Docket Number:	24-OPT-02
Project Title:	Compass Energy Storage Project
TN #:	262127
Document Title:	Compass Site Plan Update
Description:	N/A
Filer:	Erin Phillips
Organization:	Dudek
Submitter Role:	Applicant Consultant
Submission Date:	3/7/2025 6:27:05 PM
Docketed Date:	3/10/2025

RE: Compass Energy Storage Project – 24-OPT-02 - Supplemental Fire Protection Measures

DWG. NAME: CMP-D-B001-1

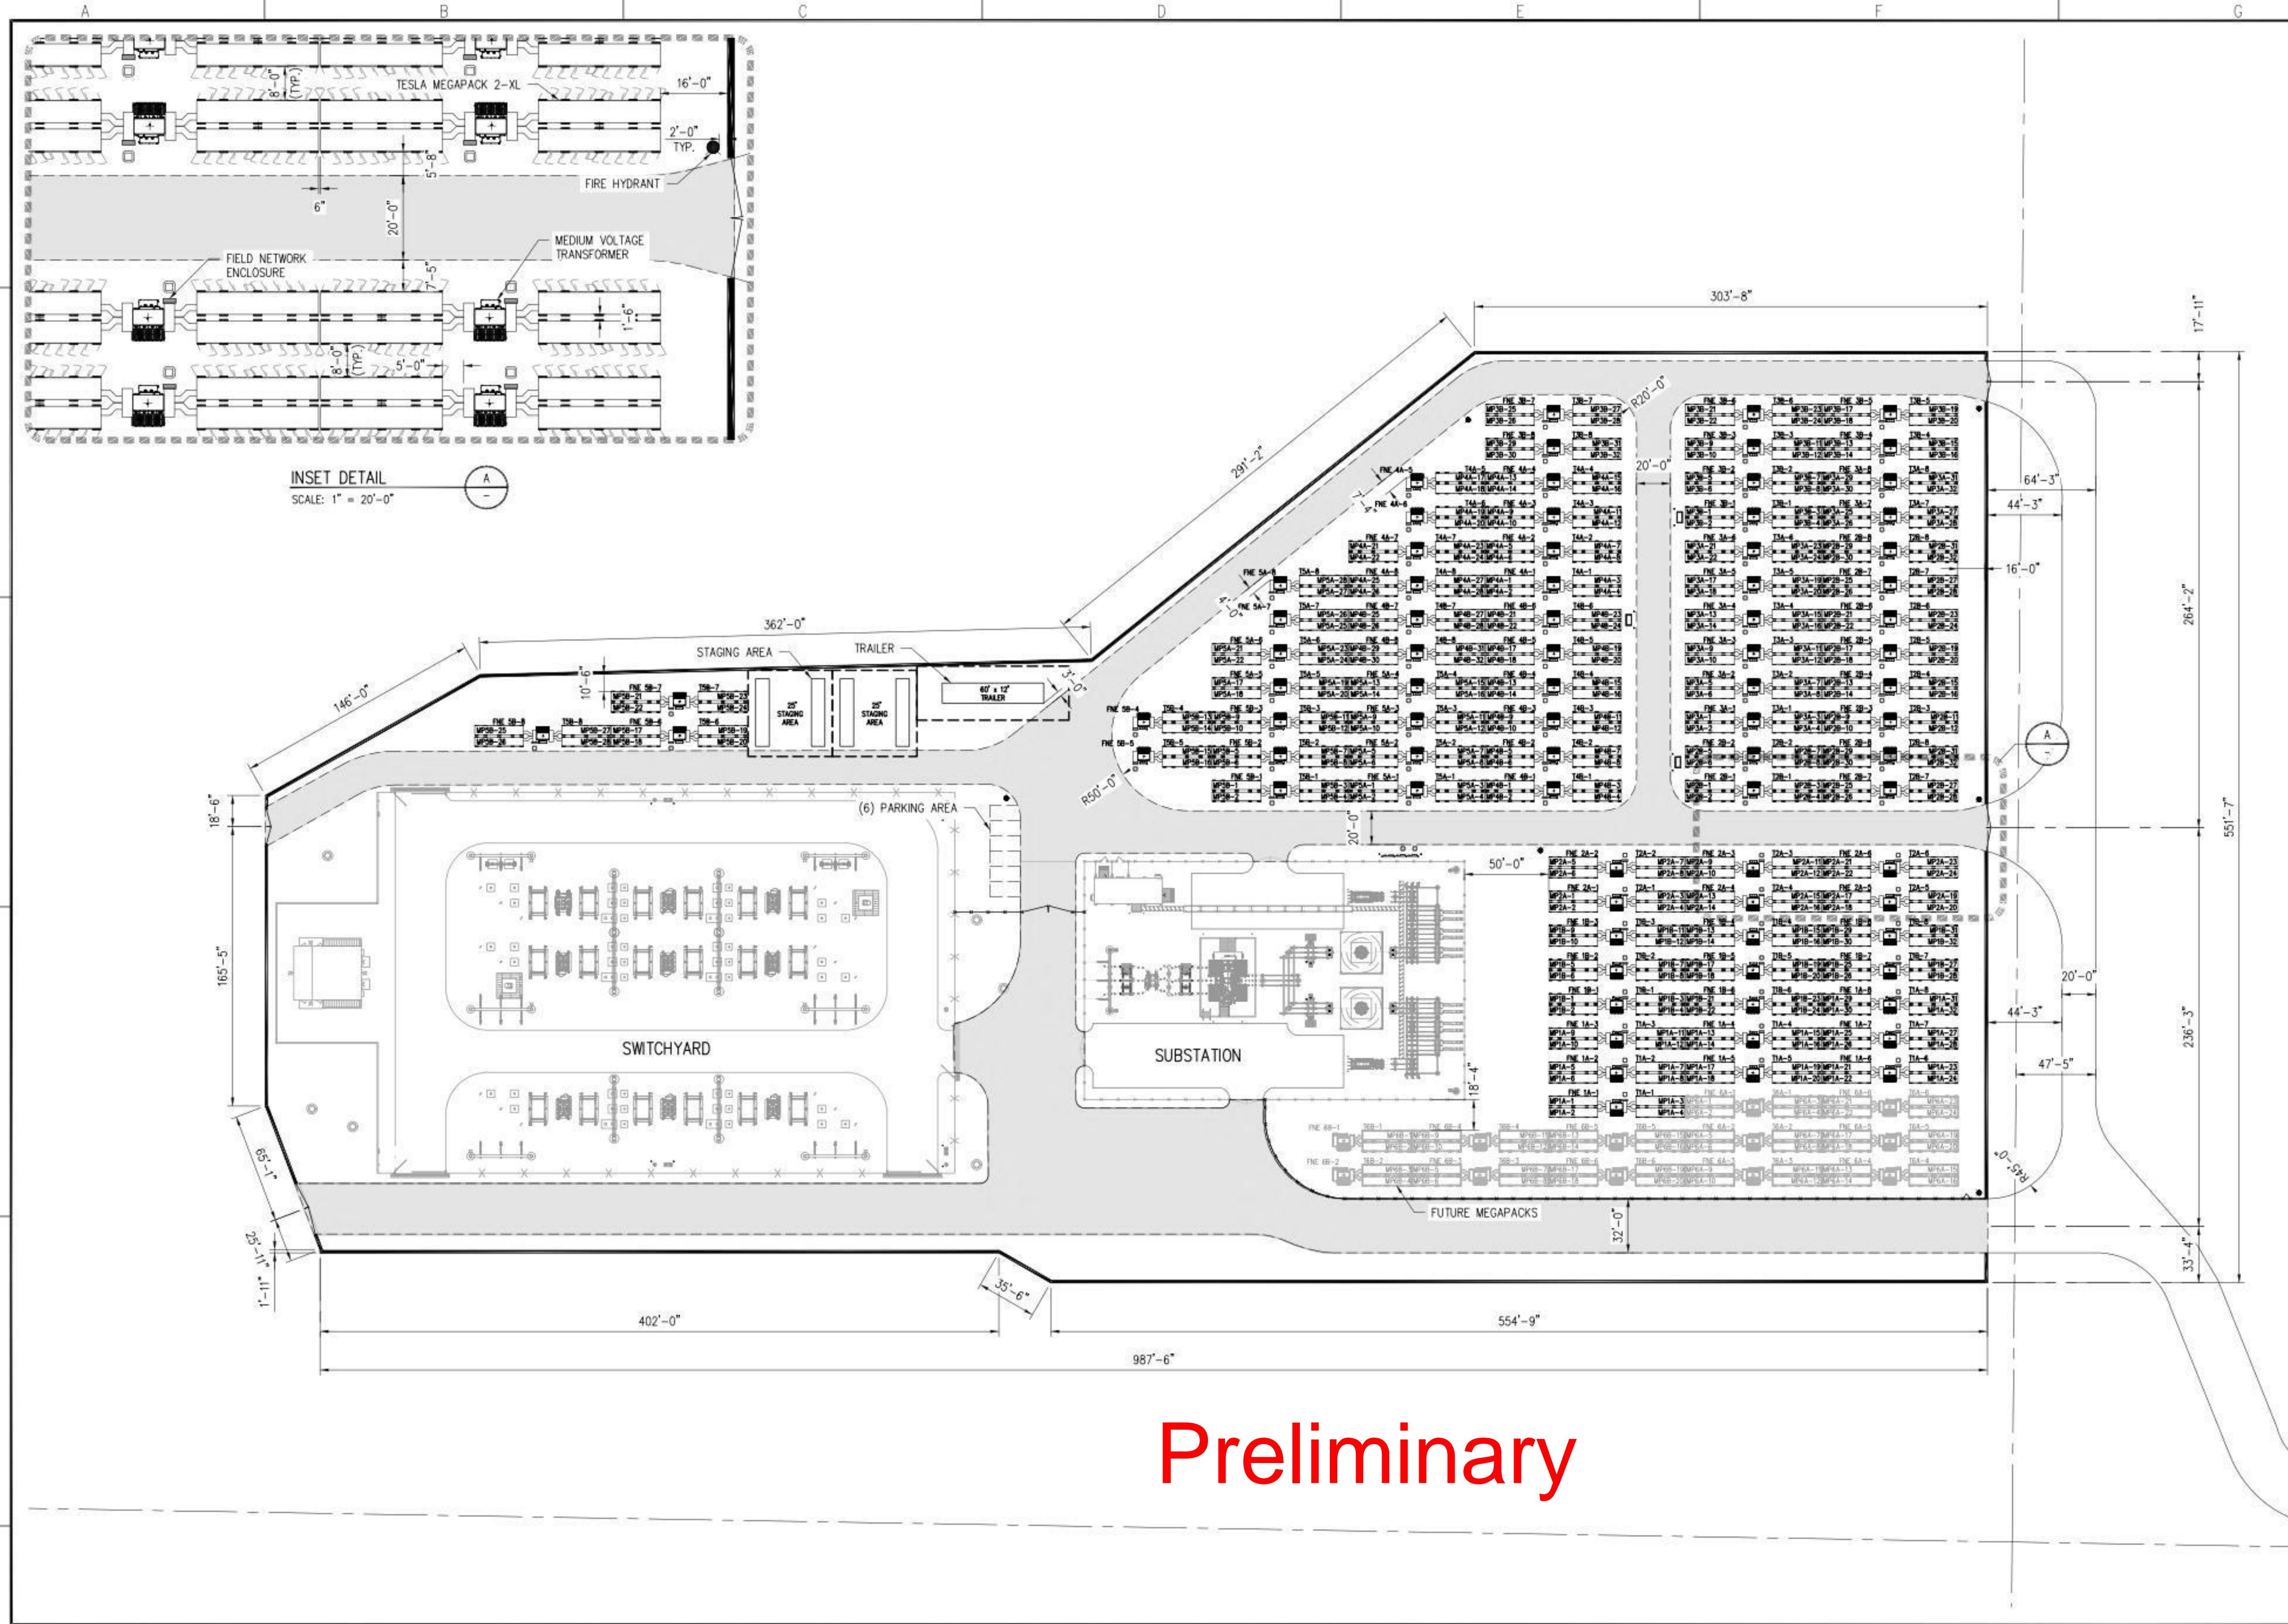
1. Addition of two (2) fire entry gates along the northern boundary of the project site.
 - a. The conceptual revised site plan adds two (2) additional gate entrances along the northern border of the site. This includes approximately 500 feet of additional perimeter access road with required turning radii. This area was covered and included within the prior biological and cultural resource survey areas (please refer to the figures within Section 4.2, Biological Resources [TN #255535-6 and #258090-2] and Figure 3 of the Archaeological Resources Management Report [TN #258743]). These changes will not significantly modify the existing drainage or grading designs or calculations. An updated conceptual site plan depicting these gates and access road are attached to this letter.

2. OCFA has requested three (3) additional fire hydrants to be located inside the project boundary. These have been added and are shown on the updated conceptual site plan attached. These additional hydrants will improve fire department resources near the control building and southern portion of the facility, without any adverse impacts to the project area.

3. The internal layout of the battery containers has been modified to provide for another internal access road as depicted in the attached updated site plan. This will ensure that the OCFA has access no further than 100 feet from any location on the site for fire management purposes. There are no impacts to site disturbance or corresponding on site stormwater management from this design change.

SHEET
LS-1

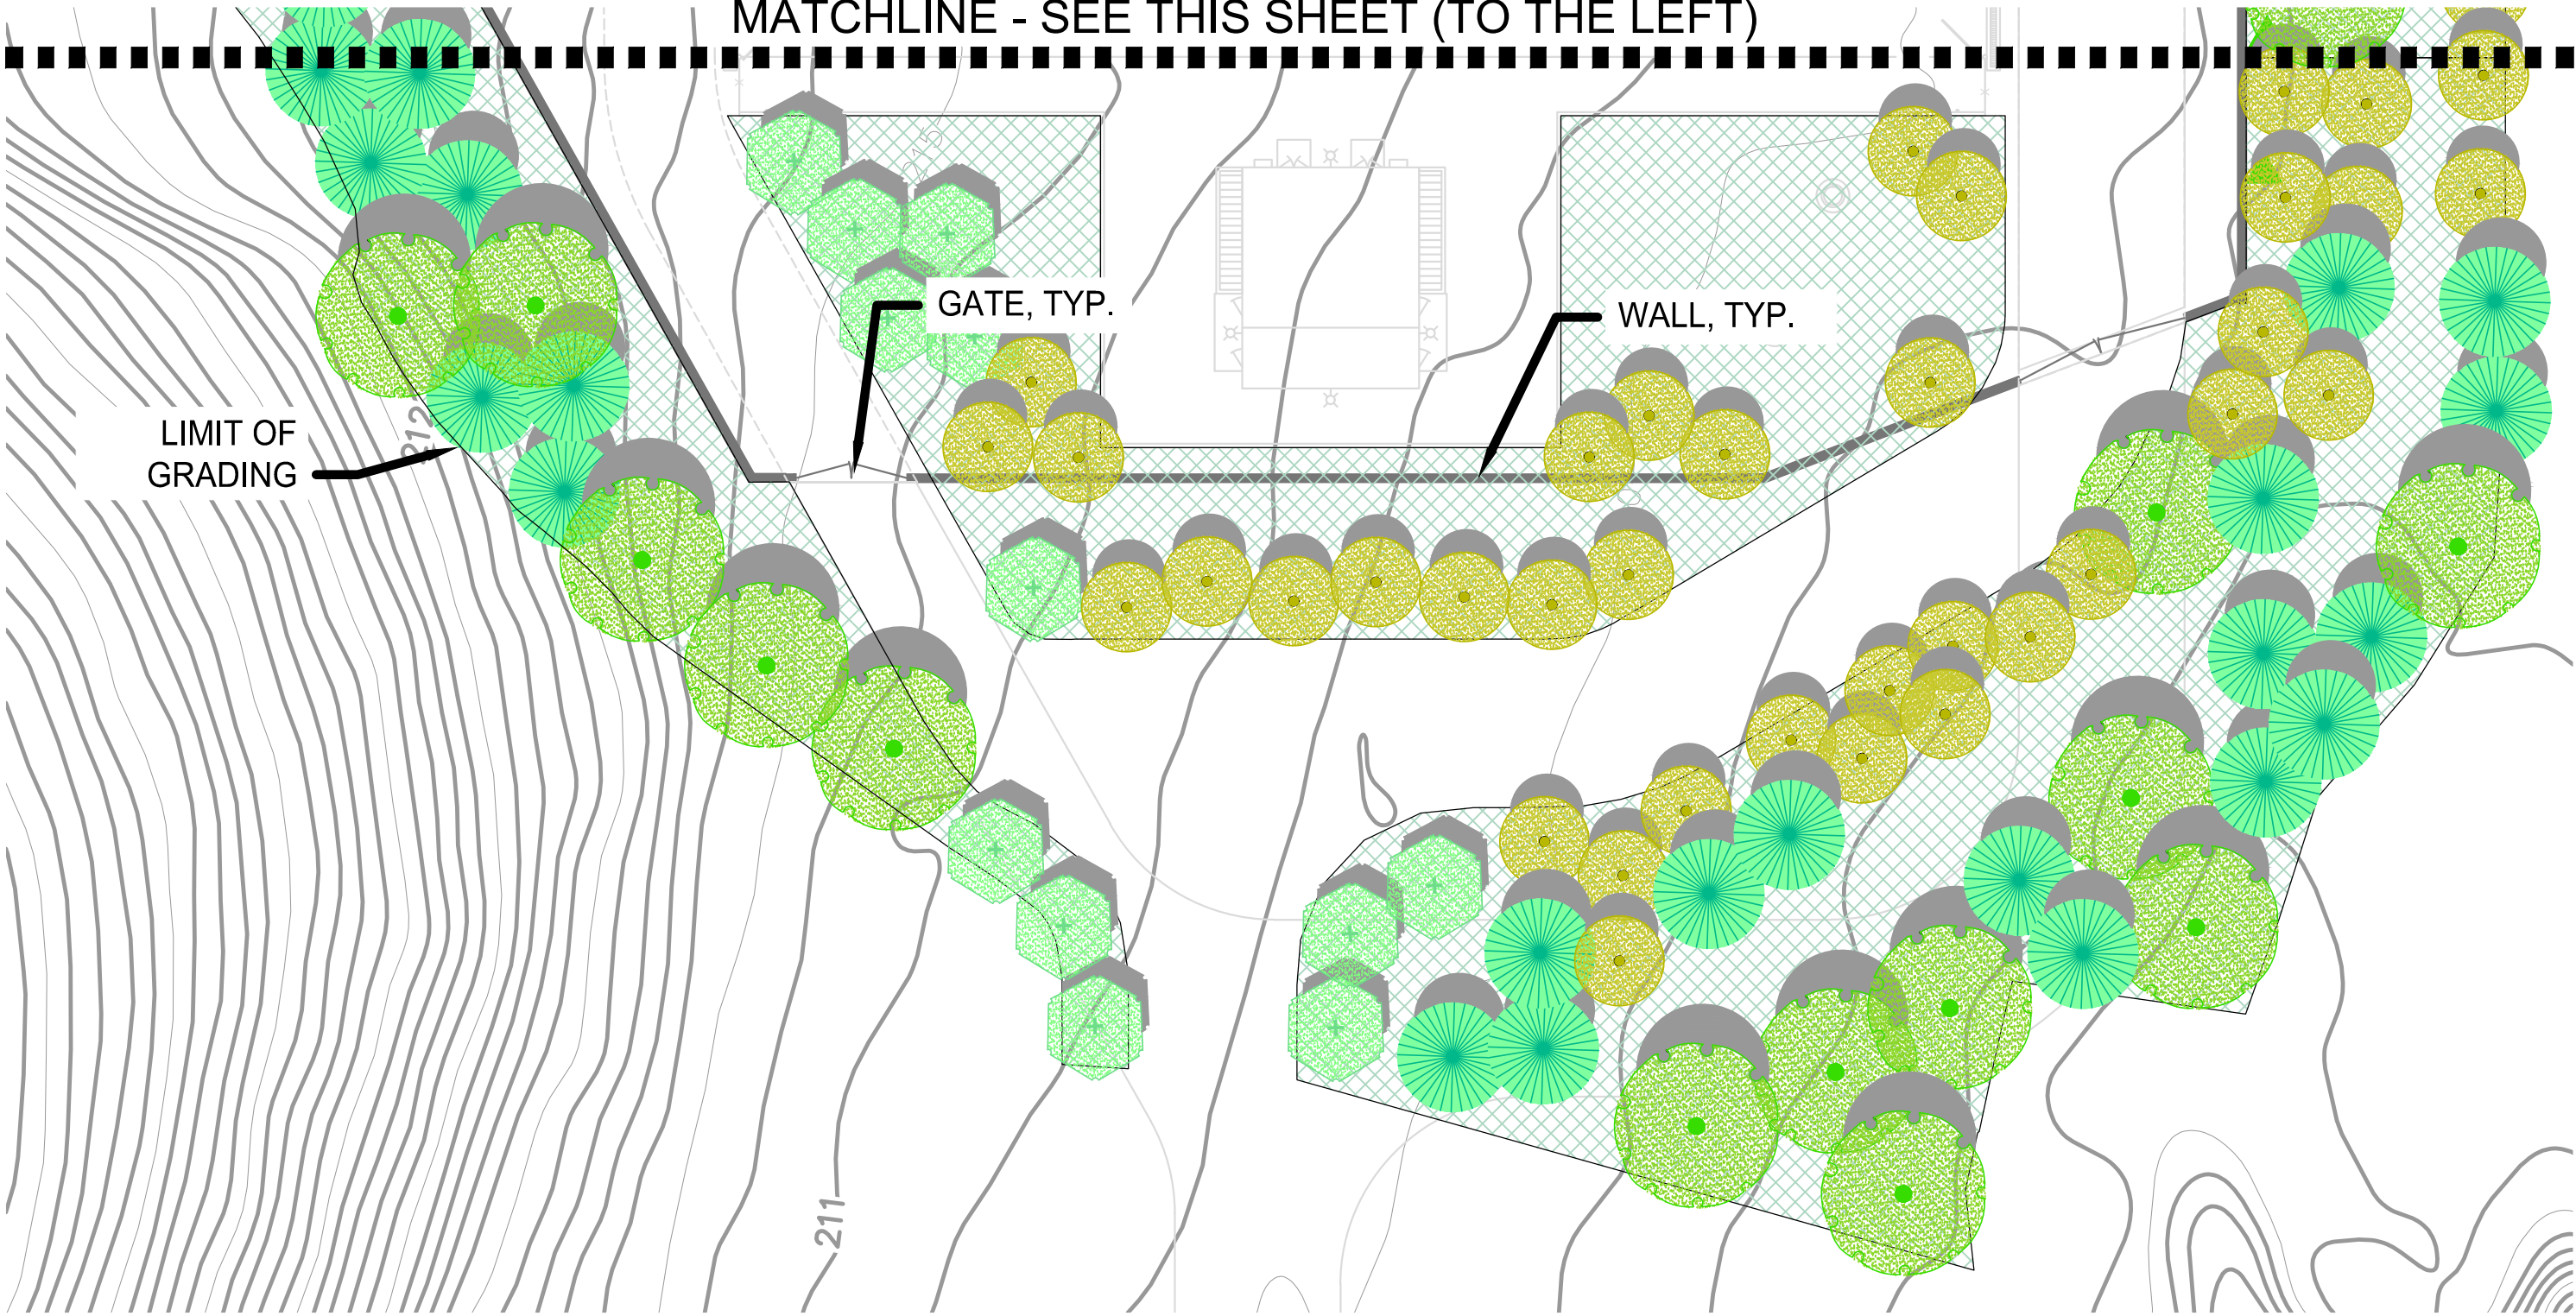
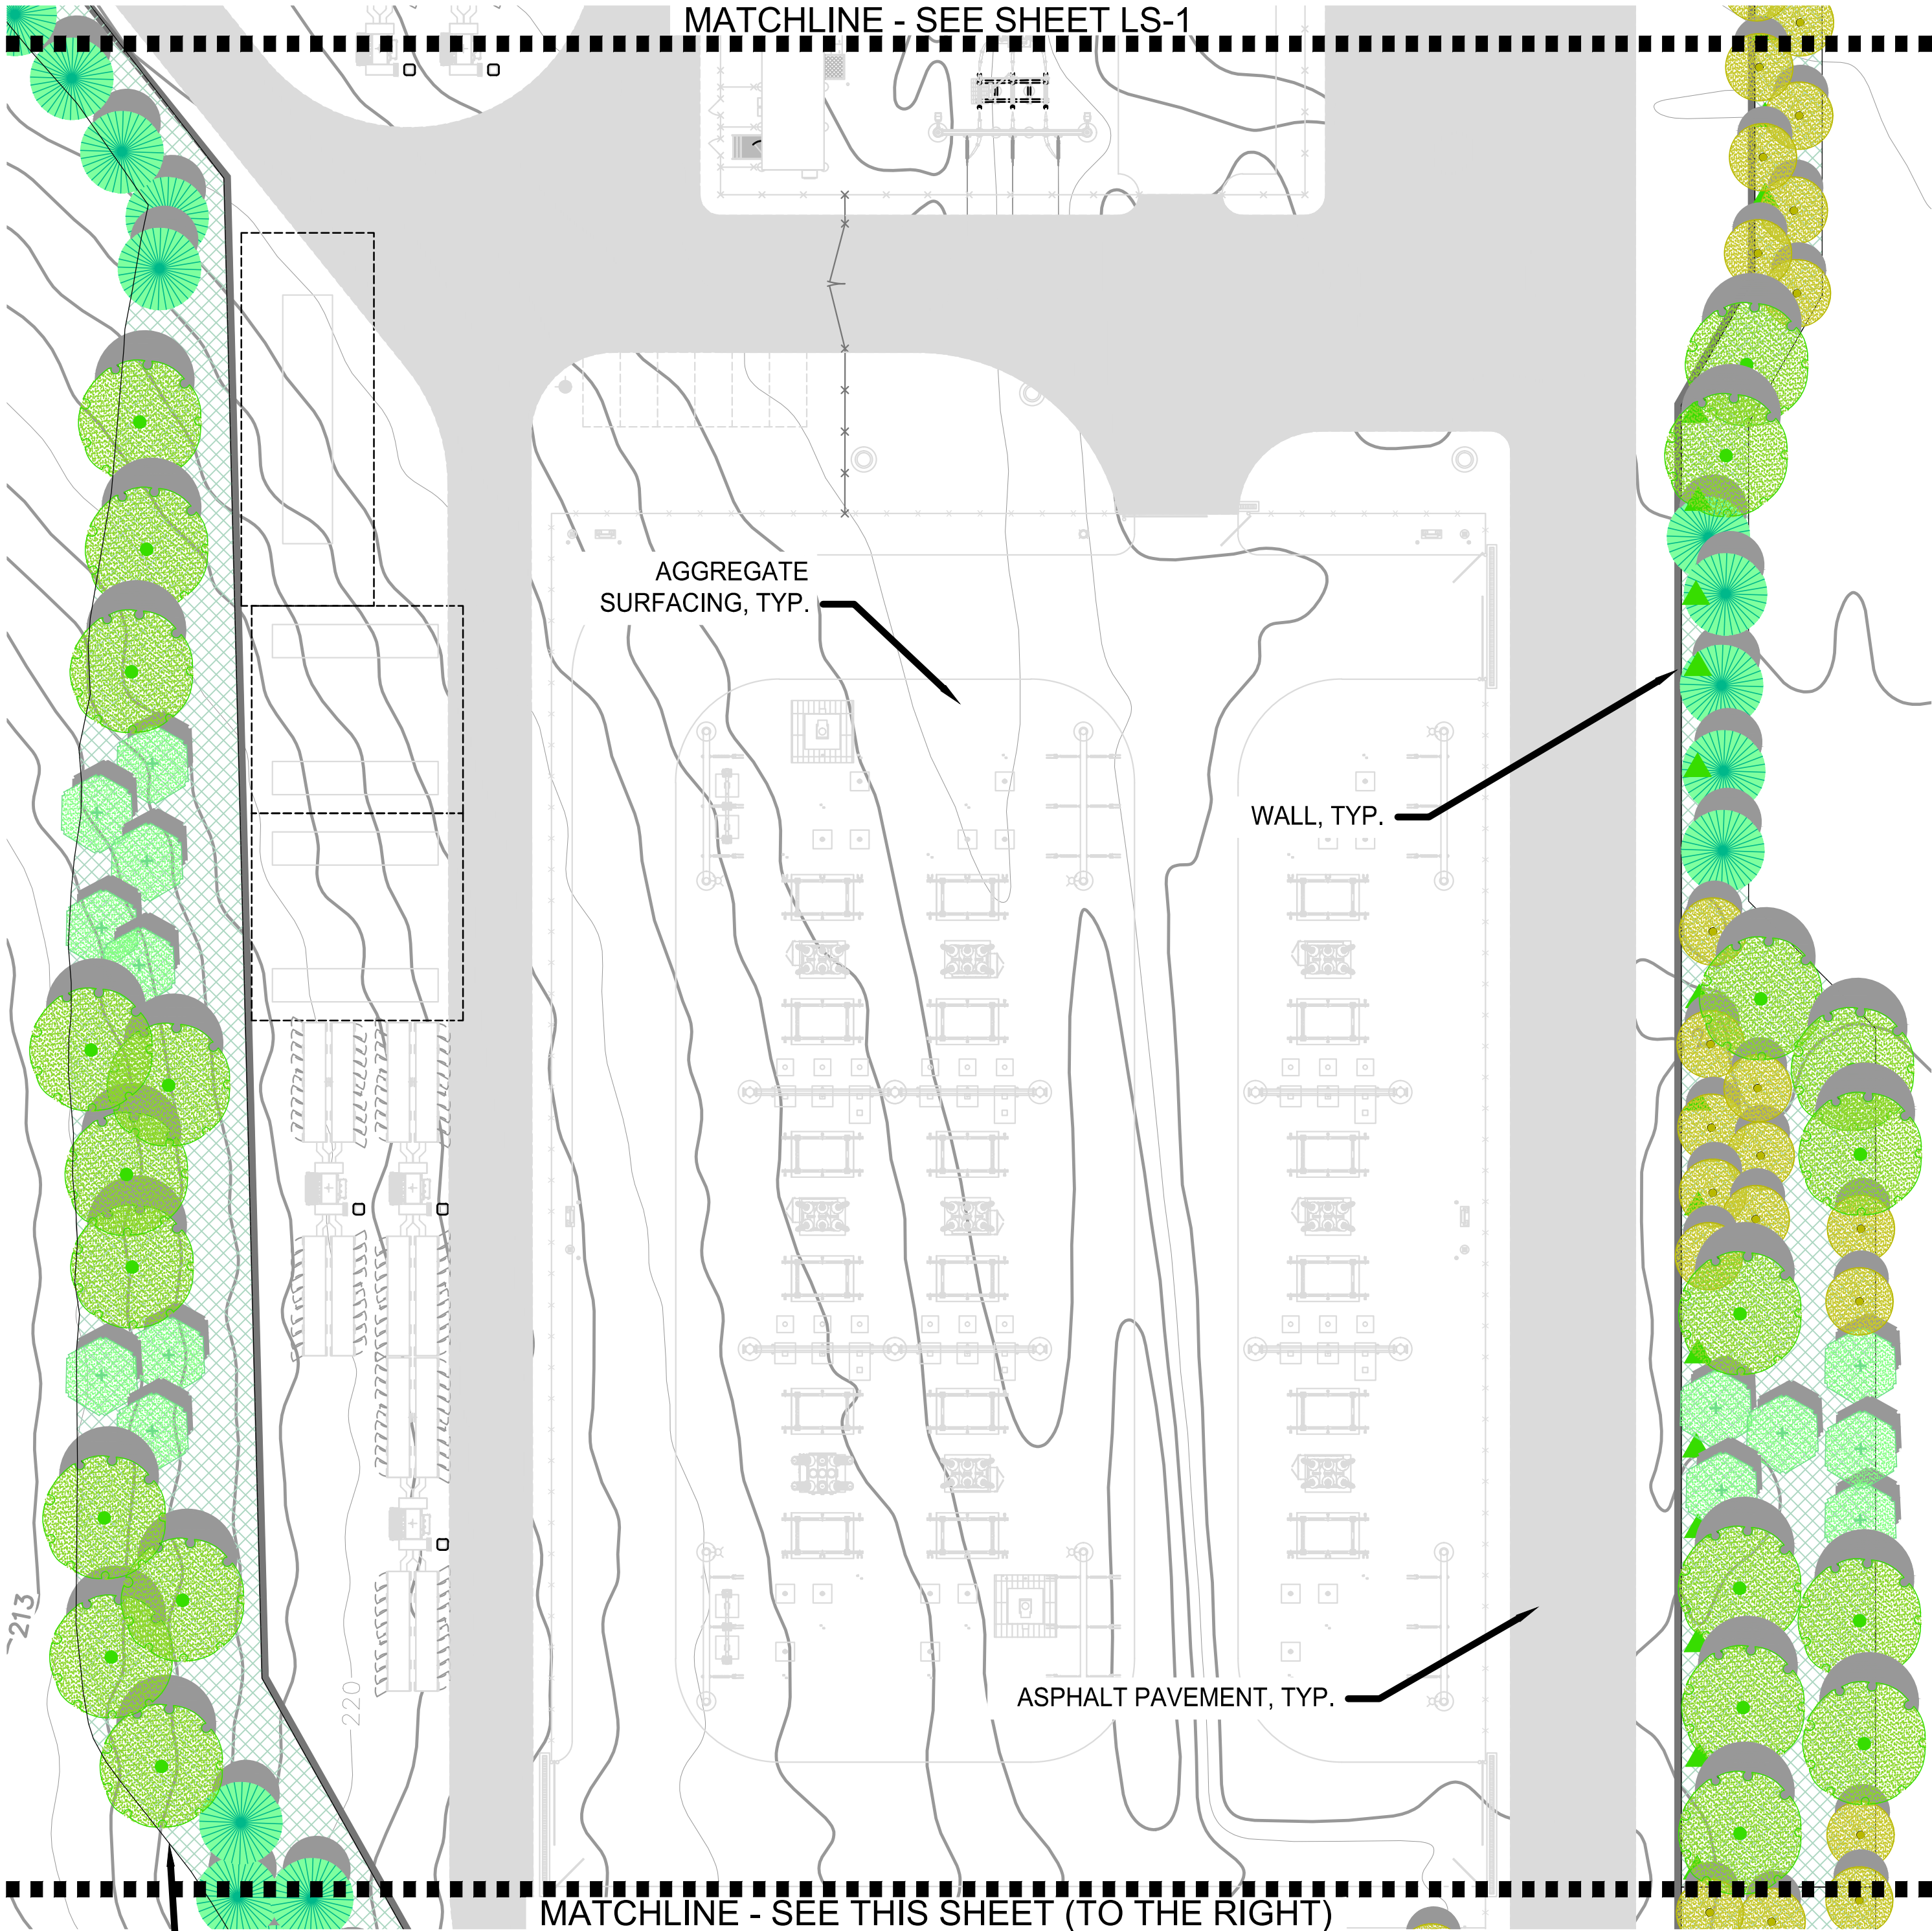
- b. The perimeter masonry wall and landscaping along the northern boundary will be retained, but will have two additional breaks to accommodate the new gates.

- ii. An update of the conceptual landscape plan is provided to show where the landscape screening will have breaks for the new gates. Final and/or additional landscaping and gate width will be coordinated with the OCFA. Gates will incorporate a compatible green color to maintain project screening to the extent feasible.
